16 Stage Coach 100%
of Amherst
Reg
Rd

PLAN OF SEWAGE DISPOSAL SYSTEM	
AT: 16 STAGE COACH RD., AMHERST, MA	
BY: FILIOS ENTERPRISES, INC. 69 PELHAM RD. AMHERST MA 01002 (413)256-8008	FOR: JANICE RATNER 16 STAGECOACH RD. AMHERST, MA 01002
DRAWN BY: P. FILIOS	SCALE: 1" = 30'
REV. #2, 27 JULY, 1994	PAGE 1 OF 2

Re: STATEMENT OF TECHNICAL DEFICIENCY
Application for: BRPWP02
Sewage variance

Re: Variance Request of Leaching System at 16 Stagecoach Road, Amherst

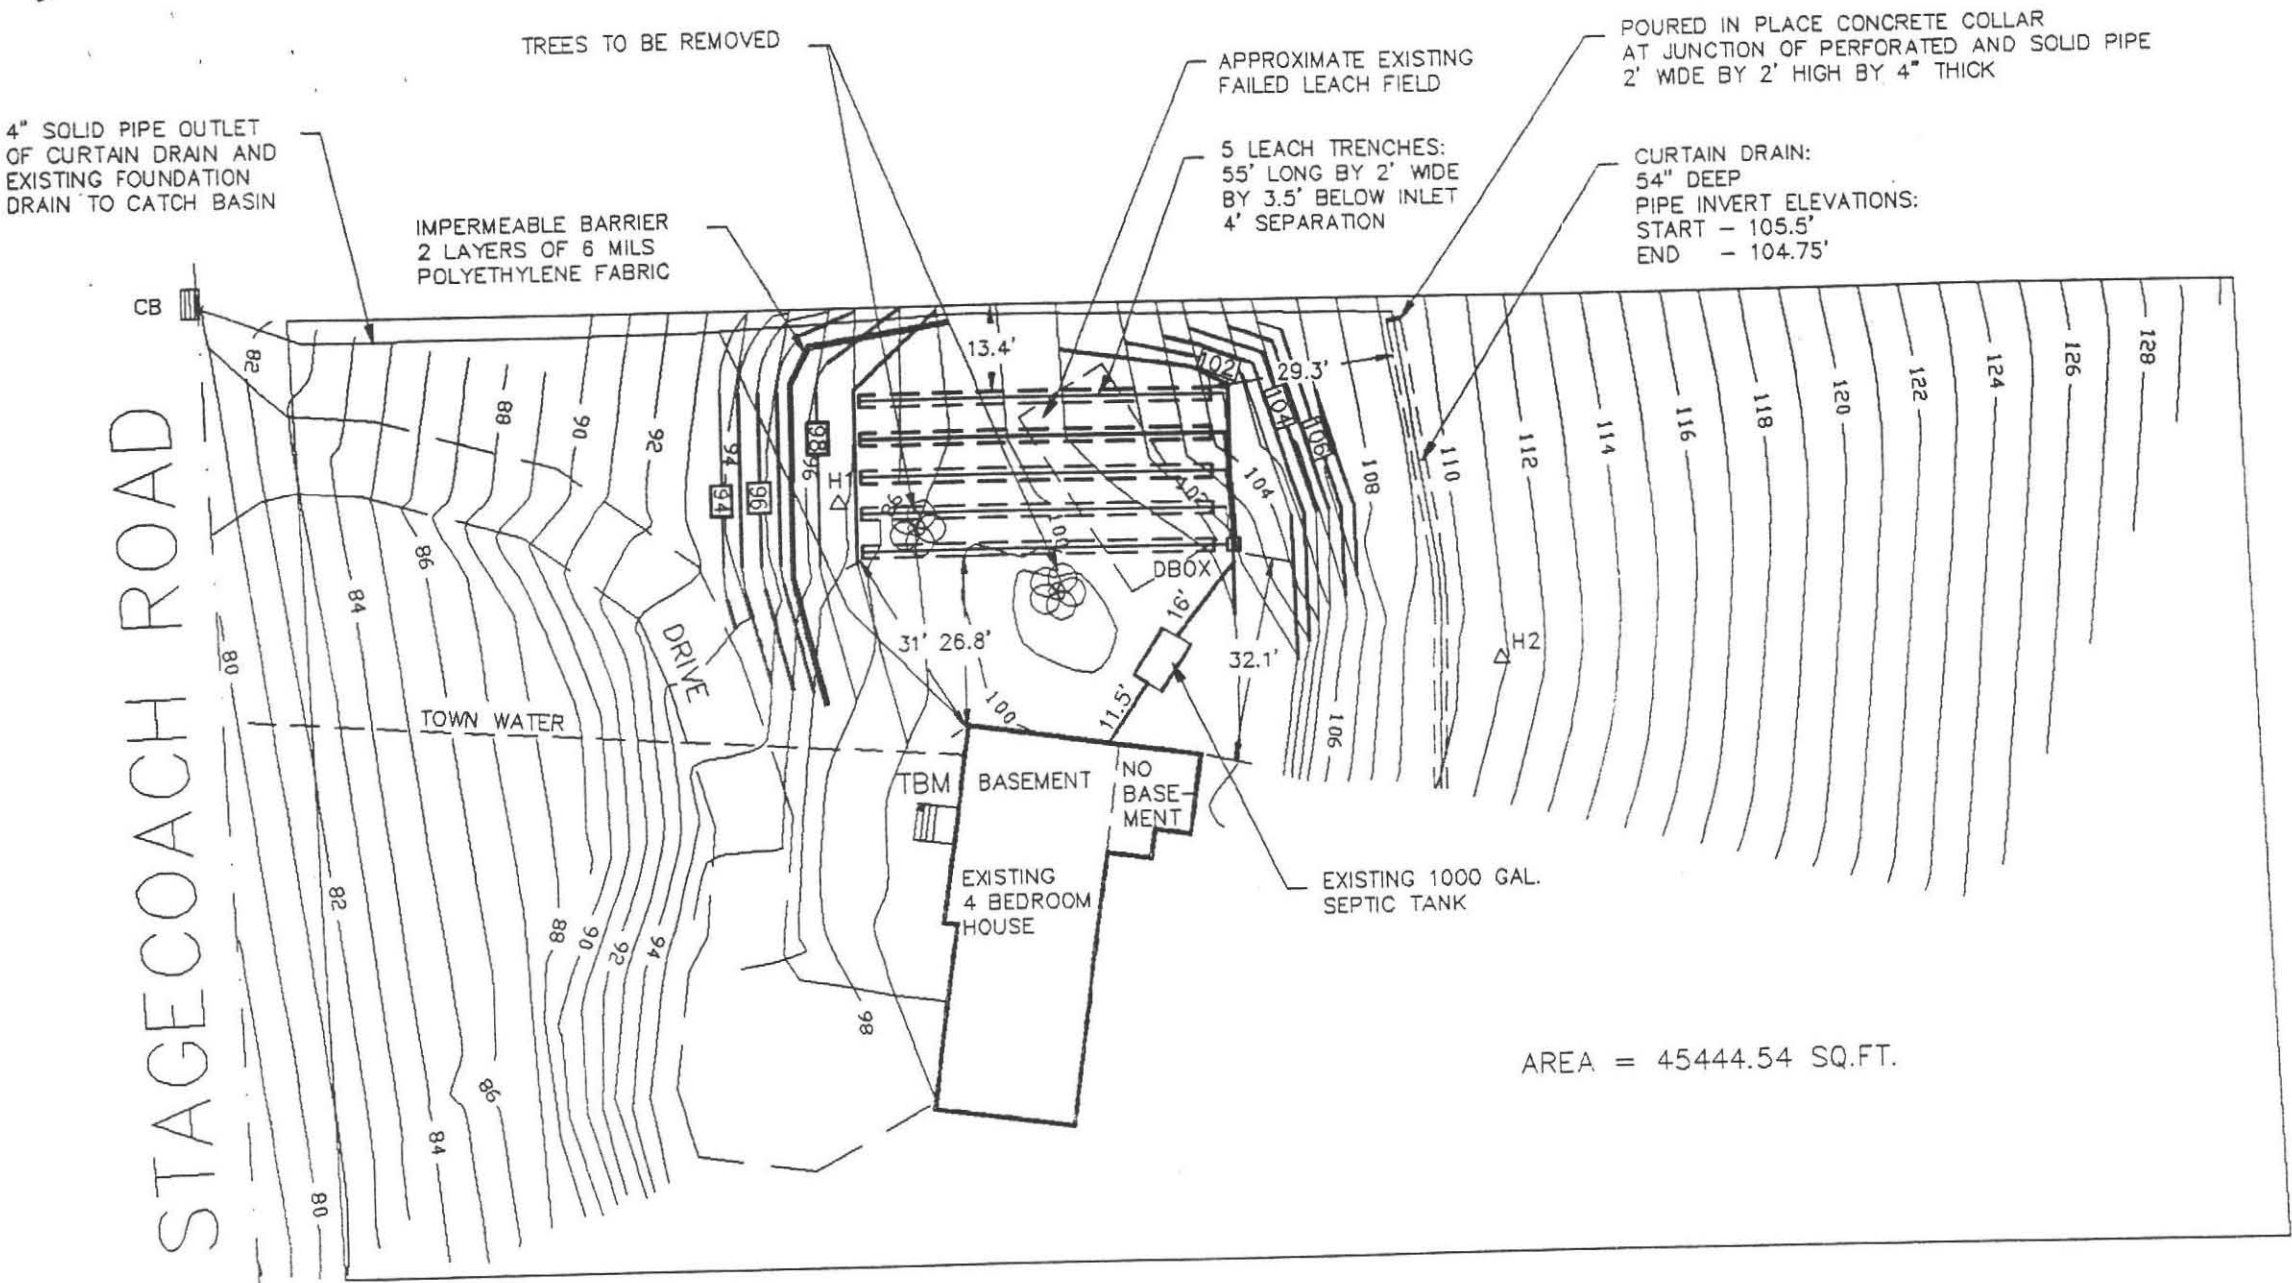
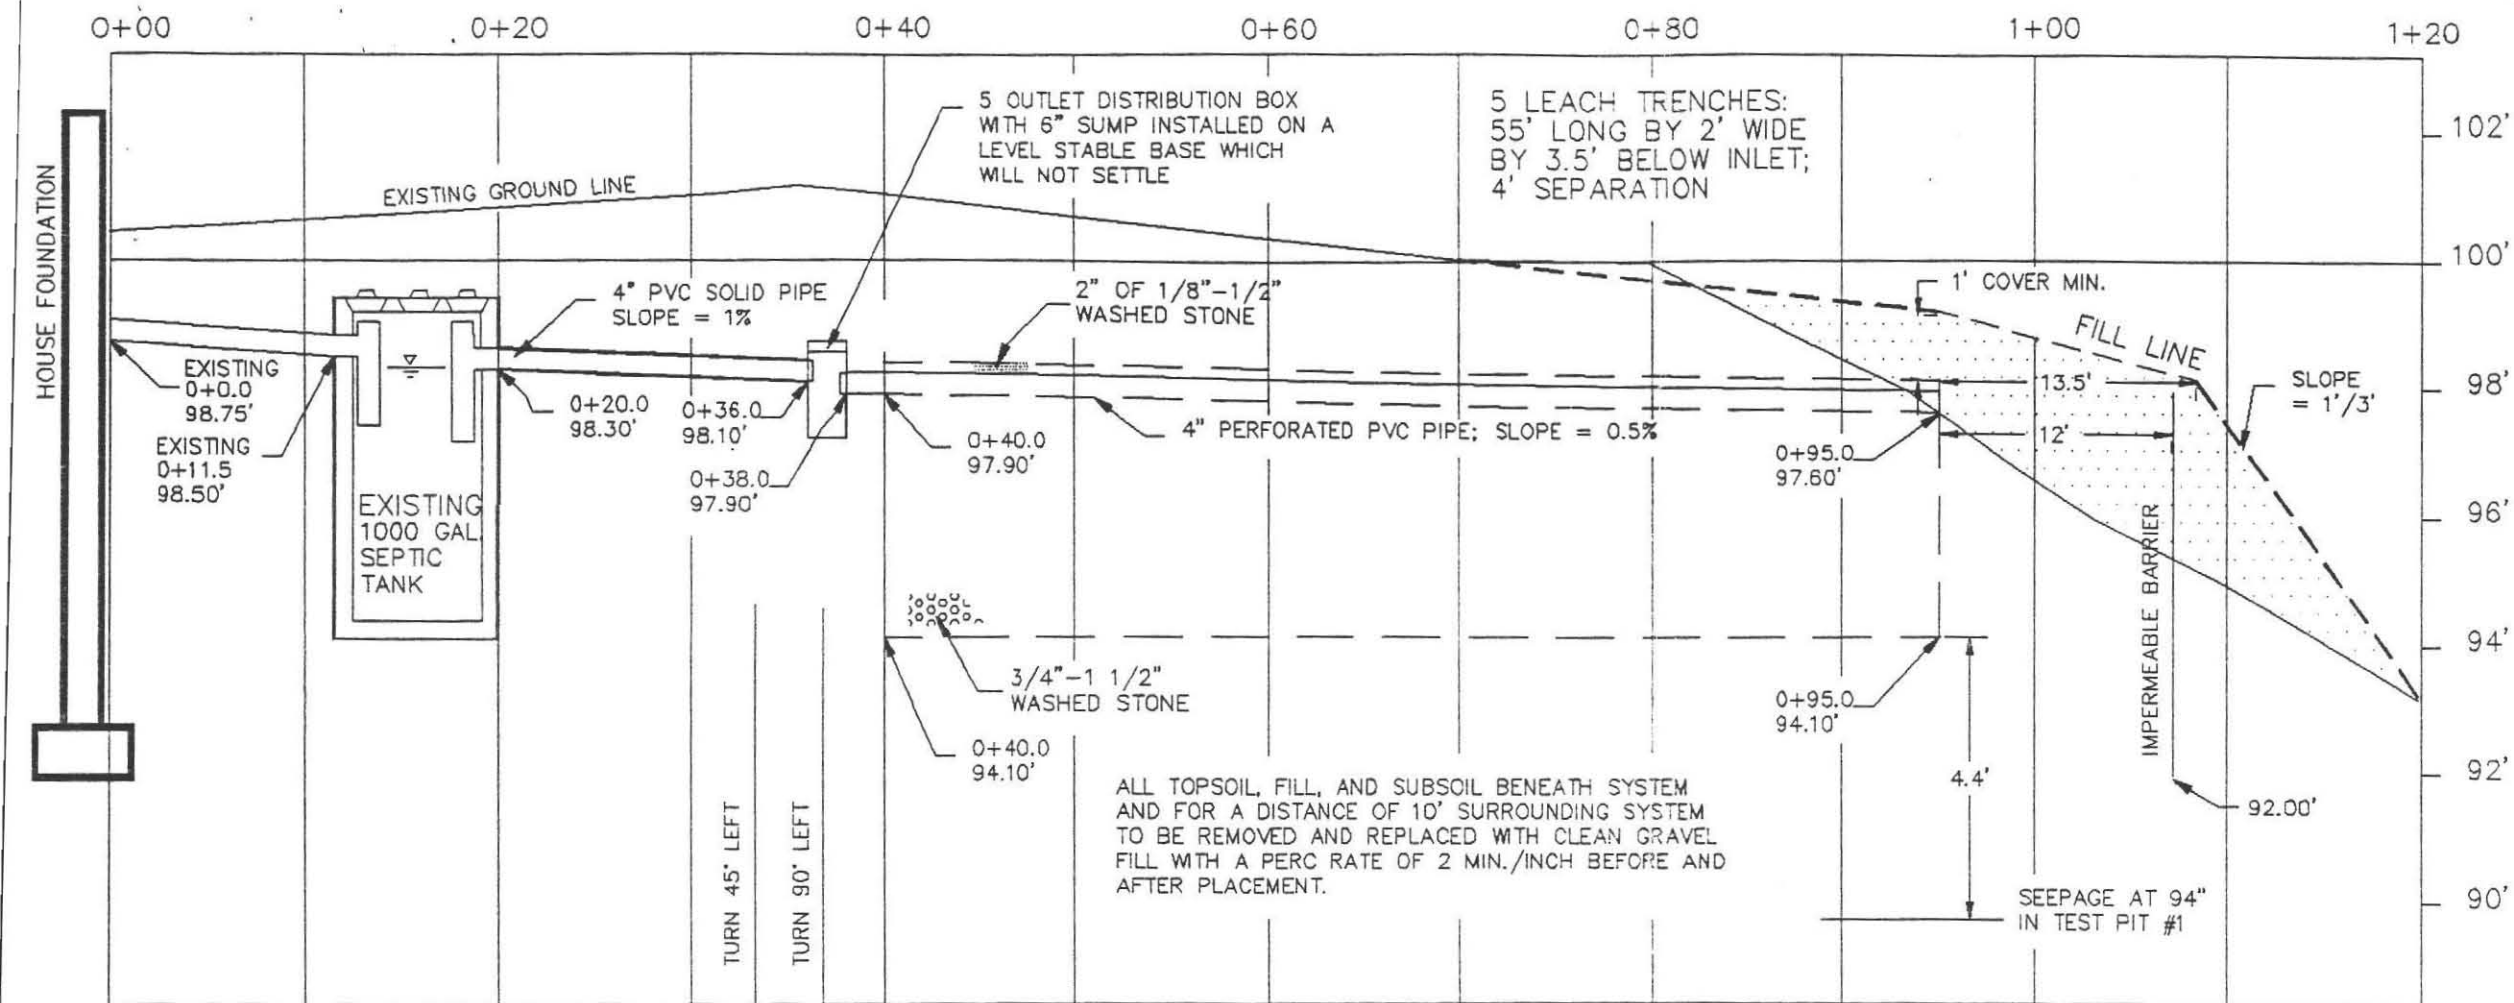
VARIANCES REQUIRED:

THIS PLAN REQUIRES VARIANCES TO TITLE 5 OF THE MASS. STATE SANITARY CODE, AND TO TOWN OF AMHERST TOWN BOARD OF HEALTH REGULATIONS AS FOLLOWS:

- TITLE 5 VARIANCES:
 - 15.03 (4) LEACHING AREA REQUIREMENTS; NOTE (5) TO ALLOW A PERCOLATION RATE OF 37.5 MIN./INCH.
 - 15.14 LEACHING TRENCHES, FIGURE 1., ILLUSTRATION B, LEACHING TRENCH, SLOPE REQUIREMENTS. TO ALLOW THE USE OF AN IMPERMEABLE BARRIER IN LIEU OF MINIMUM DISTANCES.
- TOWN OF AMHERST REGULATIONS:
 - SECTION 2 A. VOLUME OF SANITARY SEWAGE. TO ALLOW SIZE OF THE LEACHING AREA TO BE LESS THAN 1.25% OF THAT REQUIRED BY TITLE 5.

PROFILE OF SEWAGE DISPOSAL SYSTEM

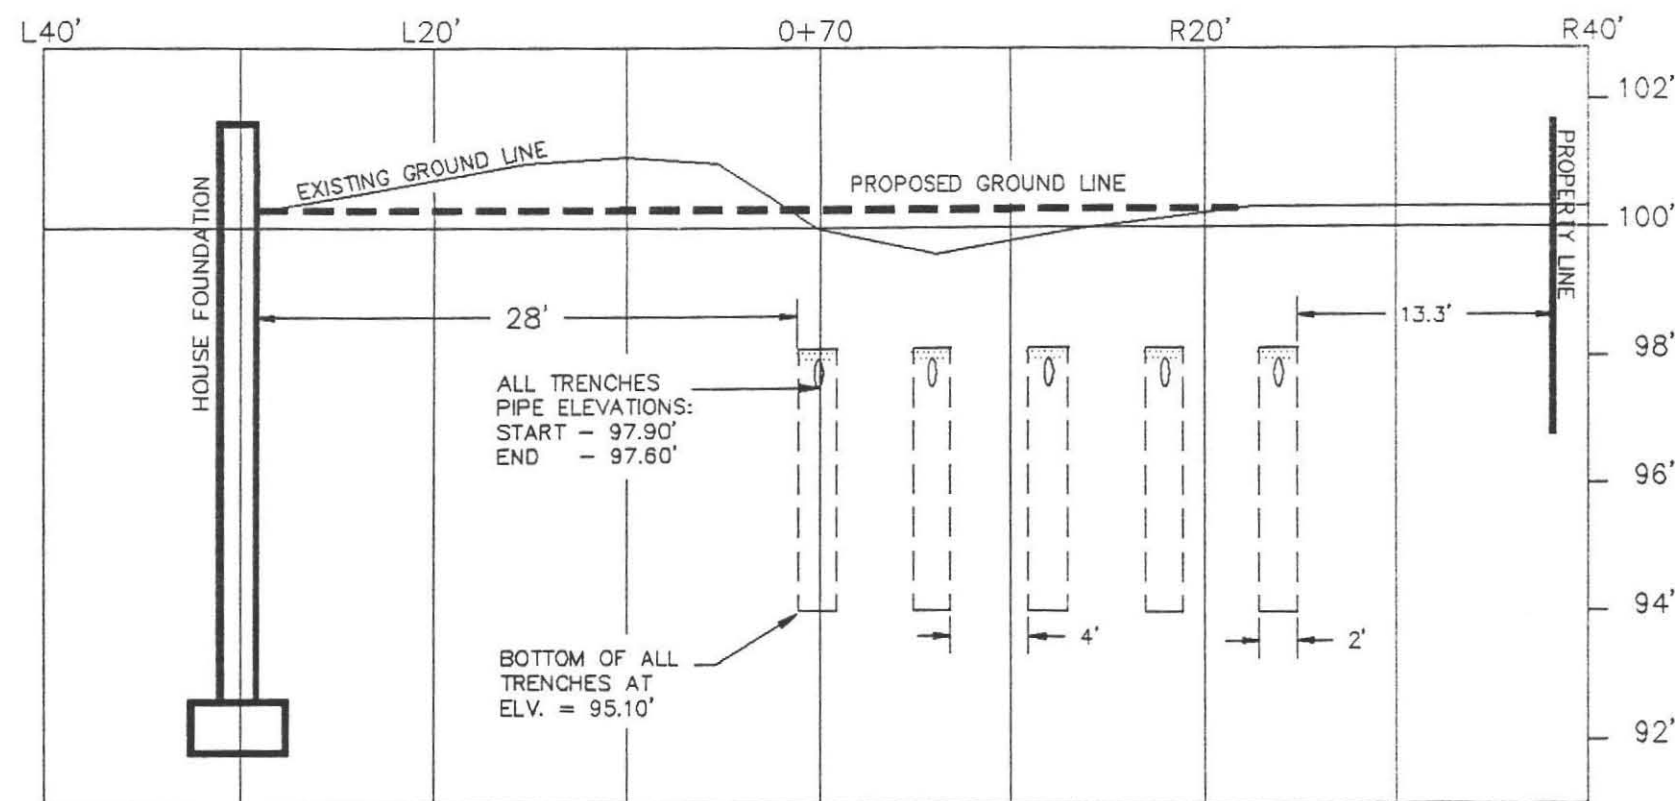
On February 16, 1994 you approved variances to the Town of Amherst Board of Health regulations for the property located at 16 Stagecoach Road and you recommended that the Department of Environmental Protection (DEP) approve requested variances to Title 5 of the state sanitary code. The DEP on April 26, 1994 denied the request for variance pending receipt of two items: a completed Wetland's Determination of Applicability form, and a change in the calculations showing that no bottom area be used in determining the system size.

1. A completed Wetland's Determination of Applicability form. This document must be signed by the Chairman of the local Conservation Commission, and must contain the determination.
2. The leaching area availability must be recalculated. Pursuant to 310 CMR 15.03(4)(e) no bottom area is allowed for a percolation rate over 20 minutes per inch.

The plans have been revised to show no bottom area is used in calculating the size of the system; the revised plans are enclosed.

CALCULATIONS

REQUIRED: For a 4 bedroom house without a garbage grinder a capacity of 440.0 gal./day.

DESIGNED: 5 leach trenches 55.0'L X 2.0'W X 3.50' below inlet (effective depth), for a perc rate of 30 min./in., yielding side and bottom loading factors of 0.232 and 0.0 gal./sq.ft. respectively.

SIDEWALL:	10 Sides(55.0' X 3.5')0.232 Gal./Sq.Ft.	= 446.6 Gal.
BOTTOM:	5 Trenches(55.0' X 2.0')0.00 Gal./Sq.Ft.	= 0.0 Gal.
TOTAL		446.6 Gal.
